Subject: LIFTGATE OPENER SWITCH INOPERATIVE	Bulletin No: 09-037/12
	Last Issued: 08/31/2012

APPLICABLE MODEL(S)/VINS

2013 CX-5 vehicles with VINs lower than JM3KE*****119968 (Produced before April 17, 2012)

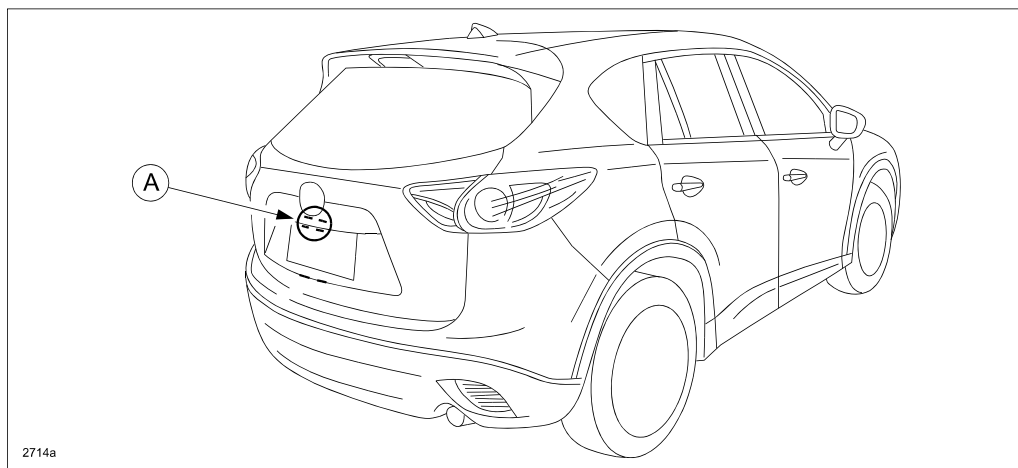
Some vehicles may have a liftgate that does not open when the liftgate opener switch (A) is pushed.

This concern may be due to water entry into the liftgate opener switch connector during a car wash or by other means of condensation. The connector terminals may then become corroded.

At mass-production, a water-proof sheet has been attached to cover the liftgate opener switch connector to prevent water intrusion.

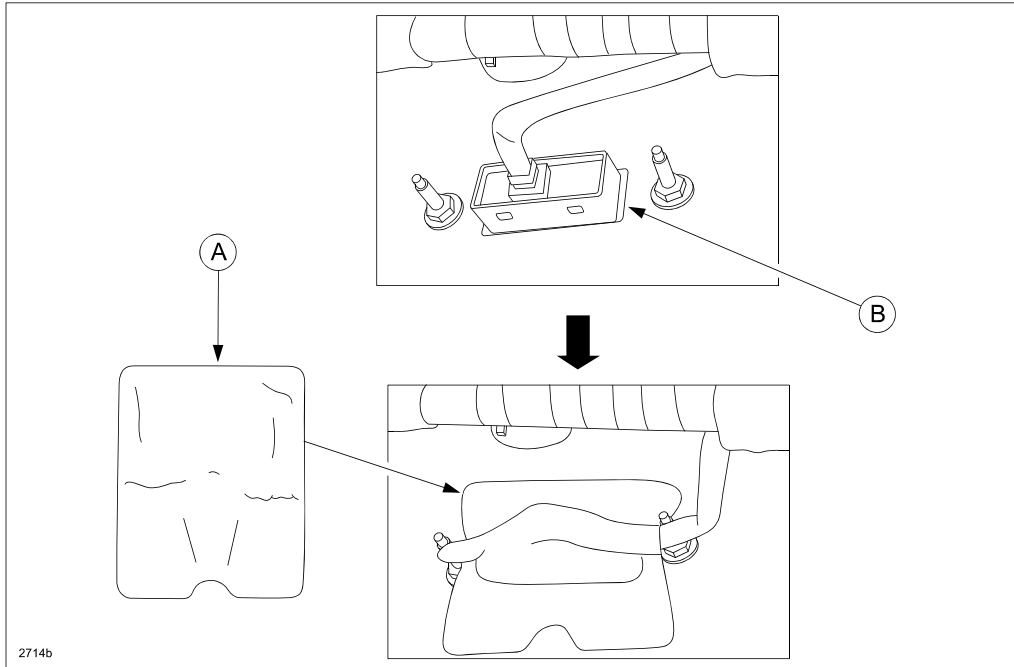
Replace the opener switch with a new one and attach a water-proof sheet (A) over the liftgate opener switch connector (B).

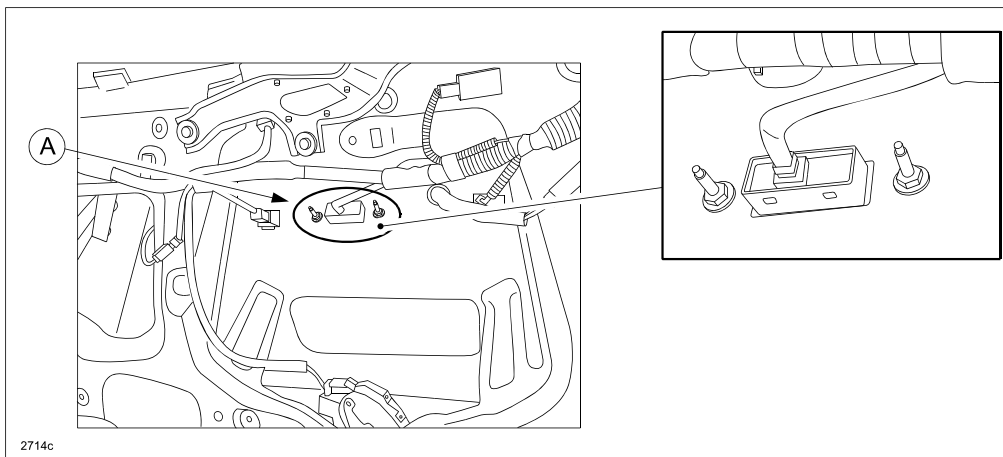
1. Verify the customer concern
2. Remove the liftgate trim according to the MS3 on-line instructions or Workshop Manual (section 09-17 LIFT-GATE LOWER TRIM REMOVAL/INSTALLATION).
3. Disconnect the connector from the liftgate opener switch.
4. Inspect for water intrusion and rust/corrosion on the terminals of the liftgate opener switch connector (A) and the Rear Harness No. 2.

NOTE: NOTE: If there is any rust/corrosion found on the Rear Harness No. 2 connector, replace it.

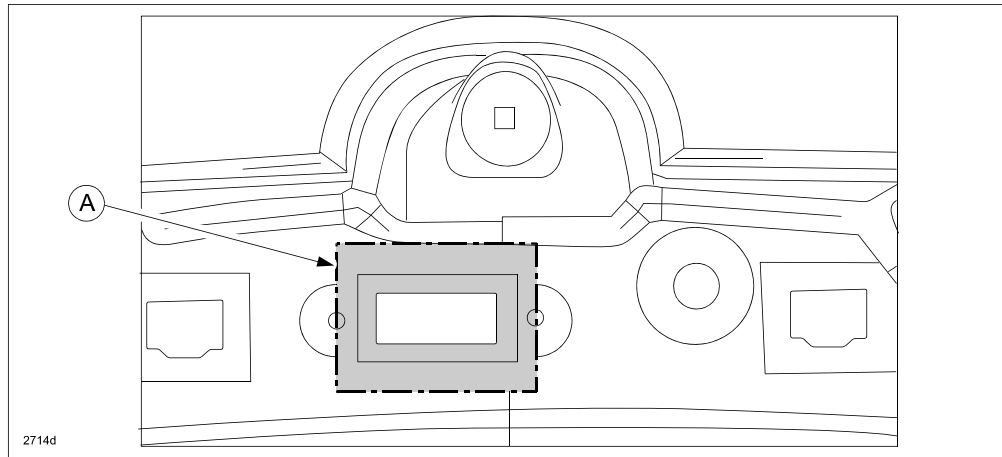
5. Remove the liftgate opener switch according to the MS3 on-line instructions or Workshop Manual (section 09-14 LIFTGATE OPENER SWITCH REMOVAL/INSTALLATION).
6. Degrease the liftgate panel around the area (A) where the liftgate opener switch is installed.

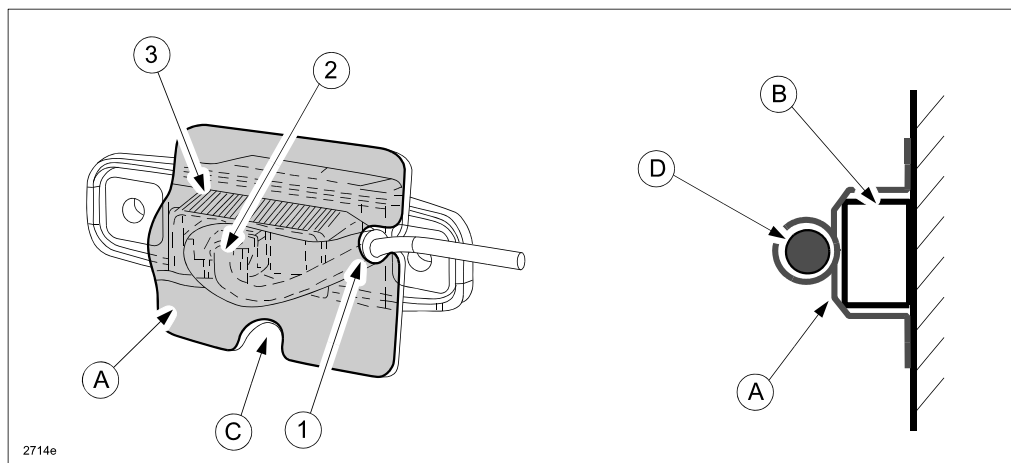
7. Install the new liftgate opener switch.
8. Attach the water-proof sheet (A) in the following order (1, 2 and 3) shown below. Fully cover the liftgate opener switch (B) with the cut-out (C) facing downward.

- (1) Attach the water-proof sheet all around the harness (D) by pinching and pressing until all gaps/clearances are gone. If there are any gaps/clearances, water may flow into the connector along the harness.
- (2) Cover the connectors tightly with the water-proof sheet.
- (3) Attach the sheet at the upper and lower part of the switch.
